Grand Canal to Lucan Urban
Greenway

Stage 1 Road Safety Audit

Document Ref:	P22-138-RSA-PD-RP-001
----------------------	------------------------------

Location: Griffin River Valley Park

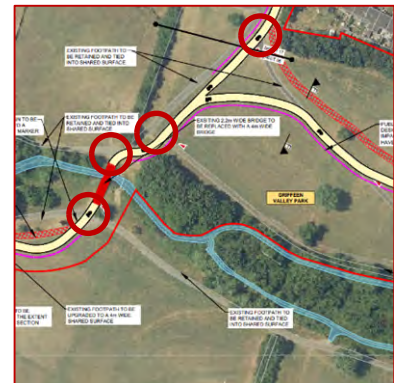
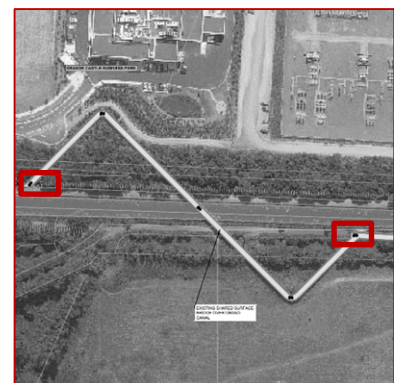
Summary: The proposal to provide a single, wide, shared path and to designate other existing paths as footpaths may increase the risk of pedestrian/cyclist collisions within the scheme.

It is proposed to widen successive sections of existing paths within Griffeen River Valley Park to create a wider Shared Path. The drawings provided indicate that the remaining existing paths will be retained as footpaths, which in many instances will run adjacent to, and cross, the newly widened shared path.

During the Site Visit it was noted that pedestrians and cyclists currently share many of the existing paths through the Park, and it is anticipated that the likely cyclist desire lines to/from the residential areas adjacent the park will remain.

For example, the existing footpath along the western side of the river, within Griffeen River Valley Park is proposed to be retained, and the existing kissing gates where this footpath joins the adjacent road network to the west of the park are to be replaced with bollards, presumably to better facilitate cyclist access to the park. It is expected that cyclists would continue to use these paths when travelling to/from the residential areas nearby.

The existing paths would cross the new wider shared path at many locations, creating potential conflict points between non-motorised road users. In order to cater for the needs of visually impaired pedestrians at these intersections, and to advise them of the expected presence of cyclists on the shared path, extensive Ladder & Tramline tactile paving would be required. However, this arrangement is unlikely to correctly reflect the situation that will pertain, with all other paths likely to also contain cyclists.

The existing paths within Griffeen River Valley Park should be considered to be shared-use paths. Ladder & Tramline tactile paving would not necessarily be required at the intersections between these paths and the proposed wider Shared Path, however appropriate tactile paving treatments should be provided where these paths transition to/from segregated surfaces (e.g. at the entrances to the park).

Location: Drawing no. 284399-ARUP-ZZ-XX-DR-C-0002 (P03)

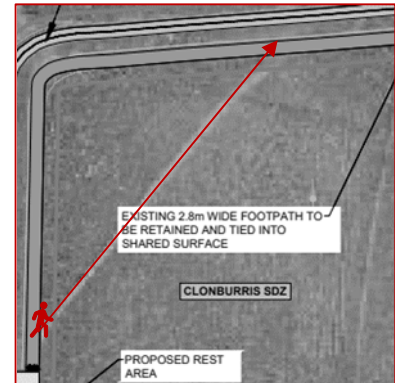
Summary: Existing & proposed path alignment does not reflect pedestrian desire lines resulting in non-motorised road users traversing unpaved areas.

The existing, and proposed, alignment of the paths between Hayden’s Lane and the Grand Canal Bridge do not reflect the existing, and likely future, desire lines at this location.

It is noted that there is an existing, established, unpaved pedestrian desire line to the southeast of the access to the park from Hayden’s Lane leading to the Grand Canal.

Consequently, non-motorised road users are likely to continue to traverse this unpaved area with resulting increased risk of slips, trips or falls in particular during wet or icy weather.

Either a path should be provided which reflects NMU desire lines at this location, or measures provided to deter NMUs from travelling across unpaved ground.

3.1	Yes	Yes		
3.2	Yes	Yes		
3.3	Yes	No	No new paths are proposed as this area will be developed as part of the Clonburris SDZ. Landscaping measures will be provided during the detailed design phase to deter pedestrians crossing the grassed areas.	Yes

Location: Drawing no. 284399-ARUP-ZZ-XX-DR-C-0002 (P03)

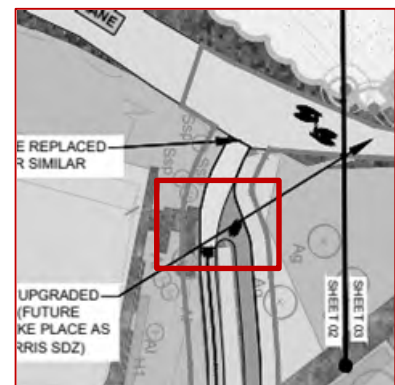
Summary: Cyclists may sight onto the shared path adjacent Hayden’s lanes, where it meets the footpath, without due care and attention, leading to pedestrian/cyclist collisions.

Pedestrians travelling from Hayden’s Lane towards the Grand Canal bridge are likely to choose to travel within the cycle track rather than the footpath as it is the more direct route for them as they exit Hayden’s Lane.

In addition, cyclists approaching the intersection with the footpath adjacent to Hayden’s Lane may fail to adequately moderate their speeds approaching the intersection of the footpath or the exit onto Hayden’s Lane, leading to an increased risk of pedestrian/cyclist collisions at the footpath intersection or vehicle/cyclist collisions at the exit onto Hayden’s Lane.

The cycle track layout at this location should be amended so that the cycle track approaches the shared path & the exit onto Hayden’s Lane in a way that encourages reduced cyclist speeds.

Location: Drawing no. 284399-ARUP-ZZ-XX-DR-C-0002 (P03)

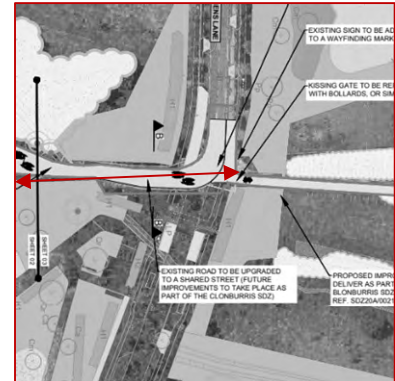
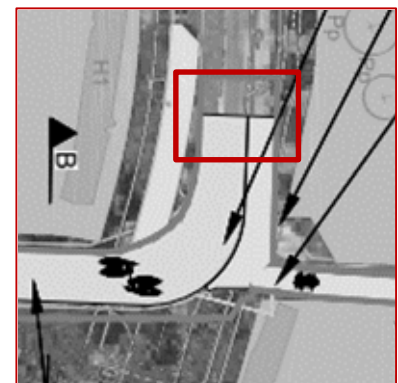
Summary: Pedestrians and cyclists sharing narrow carriageway with vehicles on Hayden's Lane.

A section of Hayden's Lane is to be utilised as part of the active travel route connecting the Grand Canal greenway with the L1058 (Adamstown Avenue) overbridge leading to Griffeen River Valley Park.

Consequently, pedestrians and cyclists will be required to share the carriageway with vehicles, leading to an increased risk of vehicle/NMU collisions.

This issue may be exacerbated by reduced visibility on the eastbound approach to the 90° bend in Hayden's Lane, at the location where pedestrians/cyclists are likely to be travelling towards the existing railway overbridge.

The proposed route should be amended so that non-motorised road users are not required to share a carriageway with vehicles. A possible route is available through the adjacent field to the east of Hayden's Lane, which forms part of the Clonburris SDZ, and which would require an overbridge over the watercourse.

3.4	Yes	Yes		
3.5	Yes	No	Measures (e.g. signage and road markings) will be provided along Hayden's Lane during detailed design to ensure a safe environment for all road users along the shared road.

Location: Drawing no. 284399-ARUP-ZZ-XX-DR-C-0005 (P03)

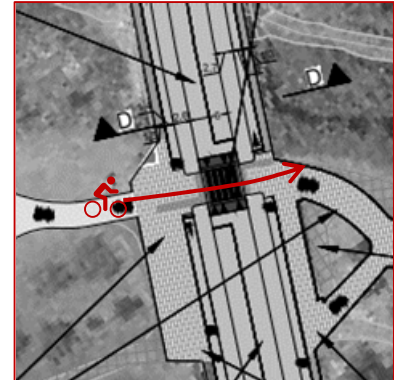
Summary: Potential for cyclists to fail to slow sufficiently at the zebra crossing of Griffeen Avenue.

It is proposed to replace the existing signalised pedestrian crossing of Griffith Avenue with a zebra crossing. It is unclear if it is proposed that the plaza area should function as a shared space, however it is assumed that this is not the proposal as separate cycle lanes have been indicated along Griffith Avenue up to the crossing location.

Consequently, the Audit Team understand that it is intended that cyclists would dismount at the end of the shared pedestrian/cyclist path and cross the plaza & zebra crossing on foot.

This is considered unlikely, resulting in some cyclists approaching the zebra crossing at speed, leading to sudden entry into the crossing which may not be anticipated by approaching drivers, resulting in them having insufficient time to react and leading to vehicular/cyclist collisions.

This concern would be more pronounced where those approaching along the shared path are on an electrically powered scooter or bicycle.

Landscaping features (e.g. raised beds) should be provided within the plaza area and positioned to encourage cyclists to slow down on the approach to the interface with the crossing.

Location: Drawing no. 284399-ARUP-ZZ-XX-DR-C-0007 (P03)

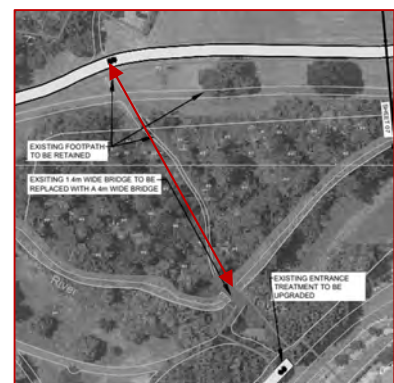
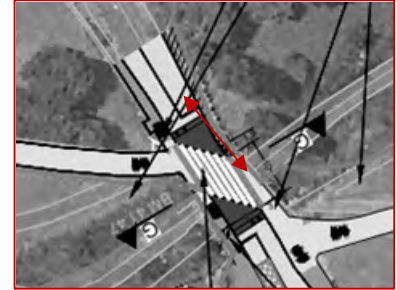
Summary: The footpaths connecting the shared facilities between Esker Manor and Griffin River Valley Park may be too narrow to safely accommodate the expected volumes of pedestrians and cyclists.

A shared facility is proposed along Esker Manor, however it does not extend to meet the proposed shared facility within Griffin River Valley Park.

It is highly unlikely that cyclists would dismount and walk along the short length of path between these two shared facilities. Should the path between the two shared facilities be of insufficient width to cater for the expected volumes of pedestrians & cyclists, in particular given its proximity to nearby schools, which could increase the risk of pedestrian/cyclist collisions.

The path within Griffin River Valley Park between Esker Manor and the proposed Shared Path should be amended to be a Shared Path and widened to cater for the expected volumes of pedestrians and cyclists.

Location: Drawing no. 284399-ARUP-ZZ-XX-DR-C-0008 (P03)

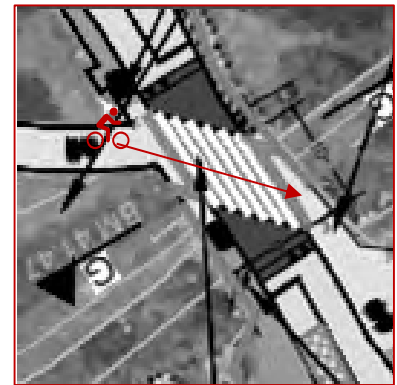
Summary: Insufficient inter-visibility between approaching drivers and a Non-Motorised Road User (NMU) approaching the proposed zebra crossing of Arthur Griffith Court.

The orientation, layout and height of the existing parapet on the western side of the bridge on Arthur Griffith Court is such that it could impede inter-visibility between an NMU approaching the western side of the proposed zebra crossing and a northbound driver, in particular if the NMU is a child or wheelchair user. This could result in a failure to stop and possible vehicle/NMU collisions.

The proposed zebra crossing should be replaced with a toucan crossing.

3.6	Yes	Yes		
3.7	Yes	Yes		
3.8	Yes	Yes		
3.9	No	No	Existing carriageway will be reduced to 6m, from 8m, which will allow adequate visibility.	Yes
3.10	Yes	Yes	Measures will be provided on the shared path approaches to the crossing to ensure sufficiently reduced bicycle/scooter speeds.

Location: Drawing no. 284399-ARUP-ZZ-XX-DR-C-0008 (P03)

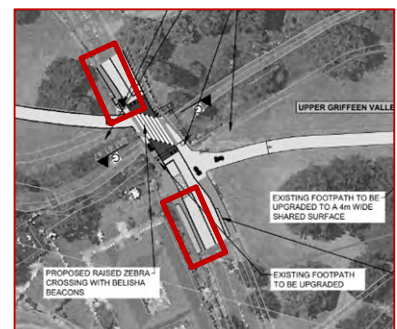
Summary: Footpath width insufficient to cater for cyclists and pedestrians.

The drawings provided indicates that the existing paths on either side of Arthur Griffith Court approaching the proposed zebra crossing are shared paths.

During the Site Visit these were noted as being footpaths only, and of insufficient width to act as shared paths. If the footpath is used by both cyclists and pedestrians this could increase the risk of pedestrian/cyclist collisions.

The existing paths along Arthur Griffith Court area should be retained for pedestrian use only, with appropriate Ladder & Tramline tactile paving provided at the intersection with the shared path.

Location: Drawing no. 284399-ARUP-ZZ-XX-DR-C-0008 (P03)

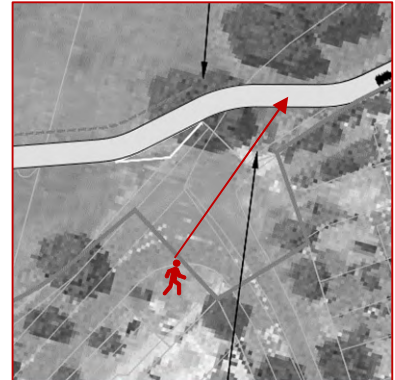
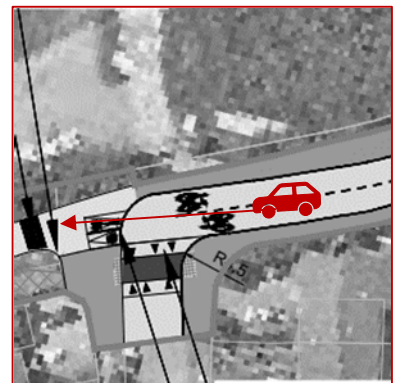
Summary: No connectivity indicated between the existing footpaths on Esker Lane and the shared path.

It is unclear from the drawings provided whether it is intended to provide paths to/from the roads to the east of the proposed shared path at the 90° bend in Esker Lane.

It is likely that pedestrian trips generated by the shared path will originate in the areas along Esker Lane to the east of the proposed shared path, and that there will be a pedestrian desire line along and across Esker Lane.

Should no connectivity be provided, including the required road crossings, this could result in pedestrians traversing unpaved ground with a consequent risk of slips, trips or falls or to unsafe crossing manoeuvres with an increased risk of vehicle-pedestrian collisions.

The likely pedestrian desire lines to/from the shared path at this location should be identified, and measures provided to cater for these desire lines safely.

Location: Drawing no. 284399-ARUP-ZZ-XX-DR-C-0009 (P03)

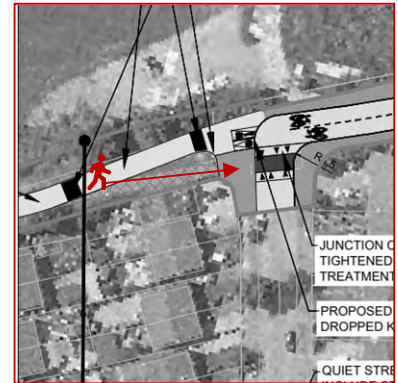
Summary: Pedestrian desire line to/from pedestrian crossing of Cherbury Park not catered for, resulting in non-motorised road users traversing unpaved areas possibly leading to slips, trips or falls particularly during wet or icy weather.

The layout of the shared path on the approach to the 90° bend where Cherbury Park meets the Lucan-Newlands Road does not align with the location of the proposed uncontrolled pedestrian crossing, possibly leading to pedestrians choosing to traverse the grassed area as they take a more direct line to/from the crossing, with resulting increased risk of slips, trips and falls, in particular during wet weather.

The alignment or width of the shared path should be amended to cater for the likely pedestrian desire line to/from the uncontrolled pedestrian crossing.

Location: Drawing no. 284399-ARUP-ZZ-XX-DR-C-0009 (P03)

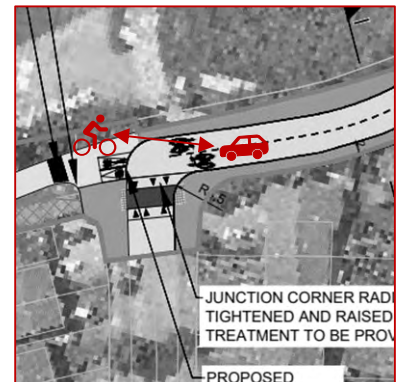
Summary: Cyclist or vehicle priority unclear where the shared path meets Lucan-Newlands Road.

The proposed road layout indicates Cherbury Park meeting the Lucan-Newlands Road, where a shared street arrangement is proposed, at a 90° bend.

This arrangement could result in confusion for drivers and/or cyclists as to who has priority at this location, resulting in unsafe manoeuvres and possible cyclist/vehicle collisions.

Cyclist and vehicle priority should be clearly defined for cyclists and vehicles at this location.

Location: Drawing no. 284399-ARUP-ZZ-XX-DR-C-0009 (P03)

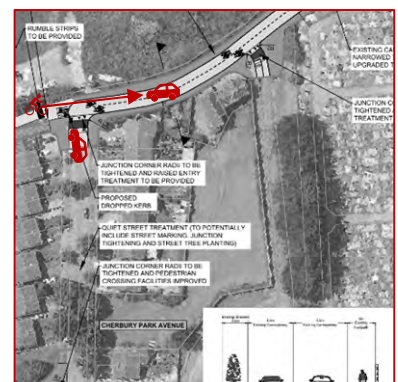
Summary: Cyclists exiting the shared path onto Lucan-Newlands Road at speed, leading to possible vehicular/cyclist collisions.

Northbound cyclists approaching the junction between the Lucan-Newlands Road and Cherbury Park may approach at inappropriate speeds as they are on a down-gradient from the overbridge, leading to overshoot into the carriageway and possible collisions with vehicles exiting Cherbury Park.

It is acknowledged that rumble strips are proposed, however these rumble strips could be misinterpreted by visually impaired pedestrians as "Ladder" tactile paving.

The proposed layout of the shared path should be amended by introducing additional landscaping (e.g. raised beds) to produce a layout which encourages cyclists to slow down sufficiently before joining the carriageway.

Location: Drawing no. 284399-ARUP-ZZ-XX-DR-C-0009 (P03)

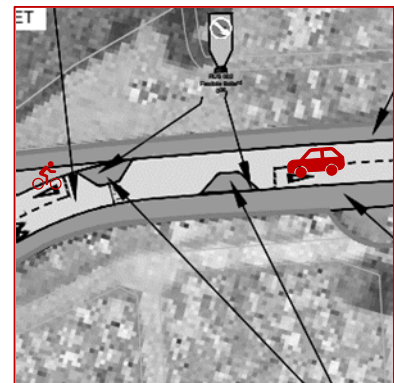
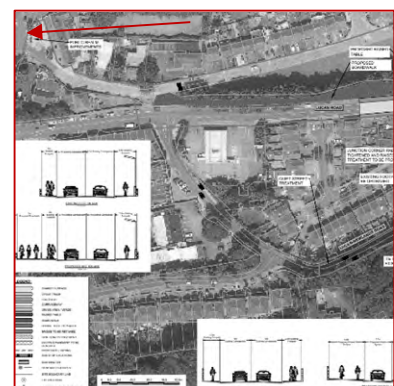
Summary: Potential for drivers to fail to give way to a cyclist at the proposed chicanes along Lucan-Newlands Road.

Three 'Give/Take' chicane arrangements have been indicated on the Lucan-Newlands Road, presumably as a means to reduce the overall speed environment along this section of shared street.

As cyclists navigate the chicanes drivers of oncoming vehicles may fail to give way to oncoming cyclists in the same way that they would give way to an oncoming vehicle, resulting in an increased risk of vehicle/cyclist collisions.

An alternate, safe, route for cyclists should be provided through chicanes along this road.

3.18	Yes	No	The existing space constraints do not allow for a segregated cycle track. Due to low traffic volumes, cyclists will utilise the chicanes in the same manner as motorised vehicles. Signage will be provided to alert vehicles to yield to cyclists.	Yes

Location: Drawing no. 284399-ARUP-ZZ-XX-DR-C-0010 (P03)

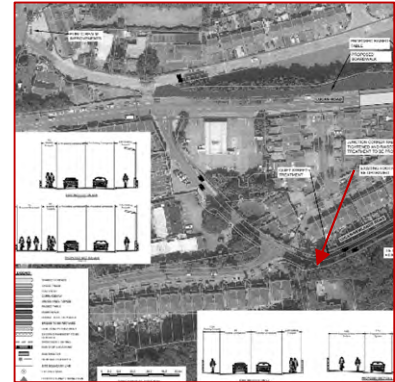
Summary: The proposed route may not adequately cater for cyclist wishing to proceed west along Lucan Road.

Cyclists travelling towards Lucan Village, and who then wish to proceed west along Lucan Road, are unlikely to use the proposed ramps/steps arrangement at Brookvale, and are more likely to travel north along the Lucan-Newlands Road towards the junction adjacent to the service station, which is not indicated as being improved and from there west along the Lucan Road.

No measures have been indicated along this section of the Lucan-Newlands Road or at the junction between the Lucan-Newlands Road and the Lucan Road. The absence of measures along this likely cyclist route could result in increased potential for conflicts between cyclists and vehicles.

Ensure the proposed cyclist route sufficiently tie-in with the existing road layout at the scheme tie-ins ensuring a smooth transition between the upgraded sections of cyclist facilities to the old sections of carriageway.

Location: Drawing no. 284399-ARUP-ZZ-XX-DR-C-0011 (P03)

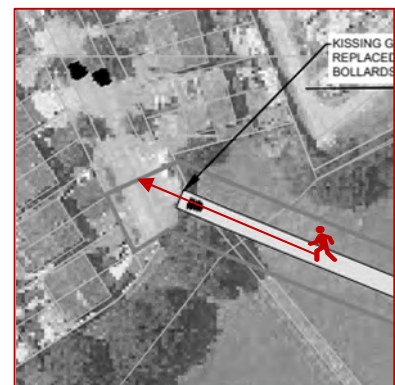
Summary: The proposed shared path connecting Beech Park to Cherbury Park does not tie in with an existing footpath.

It is proposed to provide a shared path linking the footpath on Beech Park with Cherbury Park.

However, there is no footpath where the shared path terminates at Cherbury Park which would result in pedestrians entering the carriageway leading to an increased risk of vehicle/pedestrian collisions.

The proposed shared path should extend to and tie-in with the existing footpaths on the adjacent road network.

Location: Drawing no. 284399-ARUP-ZZ-XX-DR-C-0012 (P03)

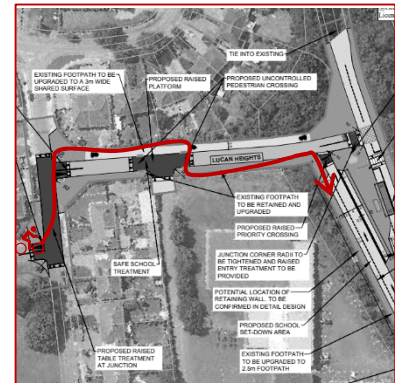
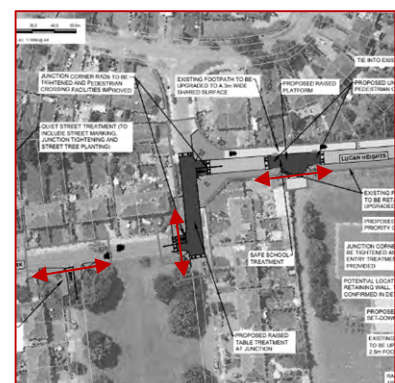
Summary: Possible pedestrian and cyclist desire lines wishing to access the school not catered for.

A short section of a shared path is indicated on the northern side of Lucan Heights, to the west of its junction with Lucan Road and within a proposed safe school zone.

It is unclear how which cyclists it is intended the shared path should be catered to, and where the cyclists should go once they reach the Lucan Road. Should no measures be provided to allow cyclist to safely transition onto the Lucan Road, and in particular to cross the Lucan Road, this could result in unsafe entry to the carriageway or unsafe crossings leading to vehicle/cyclist collisions.

It is expected that many of the cyclists approaching this area from the south will wish to access the school to the northeast, and are likely to travel within the path on the opposite side of Lucan Heights. As this path is not indicated as being widened, this could result in an increased risk of cyclist/pedestrian collisions.

The likely NMU desire lines in this area should be reviewed and appropriate measures provided to cater for the identified desire lines.

Where measures are provided for cyclists, they should terminate appropriately allowing safe entry to the carriageway downstream, and where required safe crossing arrangements.

Location: Drawing no. 284399-ARUP-ZZ-XX-DR-C-0012 (P03)

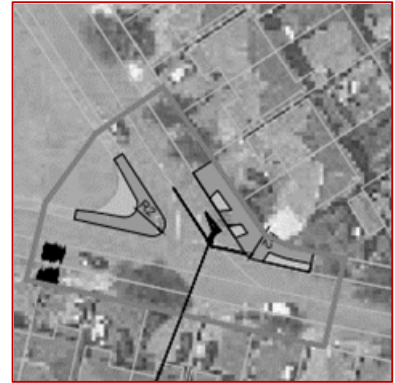
Summary: No pedestrian crossing indicated across Beech Park, Lucan Height East & School Access.

No pedestrian crossings have been indicated on Beech Park at its junction with Lucan Heights, on Lucan Heights East at its junction with Beech Park & at the School Southern Access at its junction with Lucan Heights.

An absence of a crossing arrangements at these locations could lead to difficulties for the mobility impaired, resulting in them travelling or remaining within the carriageway until they reach a location where they can rejoin the footpath.

Uncontrolled pedestrian crossings, including dropped kerbs and associated tactile paving, should be provided at these locations.

Location: Drawing no. 284399-ARUP-ZZ-XX-DR-C-0015 (P03) & Drawing no. 284399-ARUP-ZZ-XX-DR-C-0015 (P03)

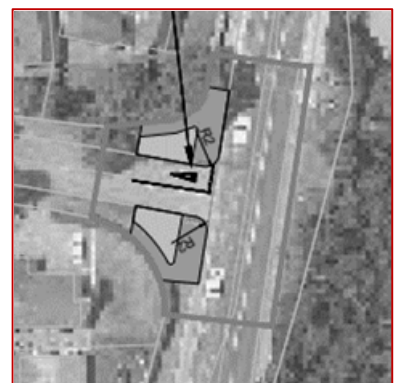
Summary: Risk of pedestrians misunderstanding the crossing layout.

The layout of the uncontrolled pedestrian crossings at the junction between Roselawn and its side road and Sarsfield Park and its side road are shown on the corners of the junction.

There is a risk of pedestrians approaching these crossings misinterpreting them as crossings of the main road, leading to unsafe crossings and possible vehicle/pedestrian collisions.

The dropped kerb locations should be moved further down the side roads, away from the main roads, such that they do not confuse approaching pedestrians as to the direction of the crossing.

Location: Drawing no. 284399-ARUP-ZZ-XX-DR-C-0015 (P03)

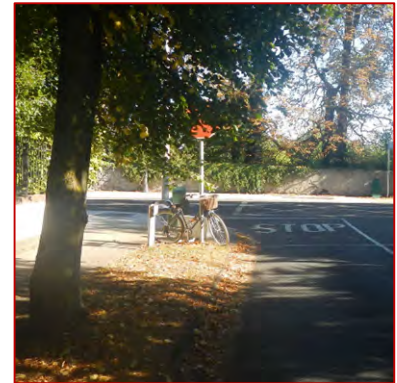
Summary: Unclear if available visibility is sufficient for 'Yield' control at the junction between Roselawn and Lucan Road.

A 'Yield' control is proposed at the junction between Roselawn and Lucan Road. The available visibility at this locations may not be sufficient for this type of junction control. This could lead to unsafe exiting manoeuvres and possible side-on collisions.

The required junction visibility should be available for exiting side road drivers, or the junction priority amended to a "Stop" control.

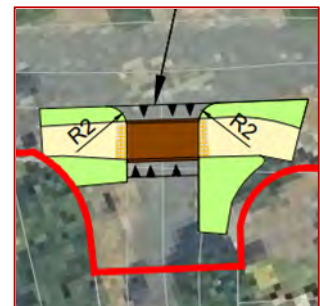
4.2 A footpath with both cycleway and pedestrian road markings has been indicated linking the shared path from the Grand Canal bridge to the segregated two-way cycleway and footpath near Hayden's Lane.

The Audit Team have assumed that this is a draughting error, and that this section of path should have been indicated as a shared path.
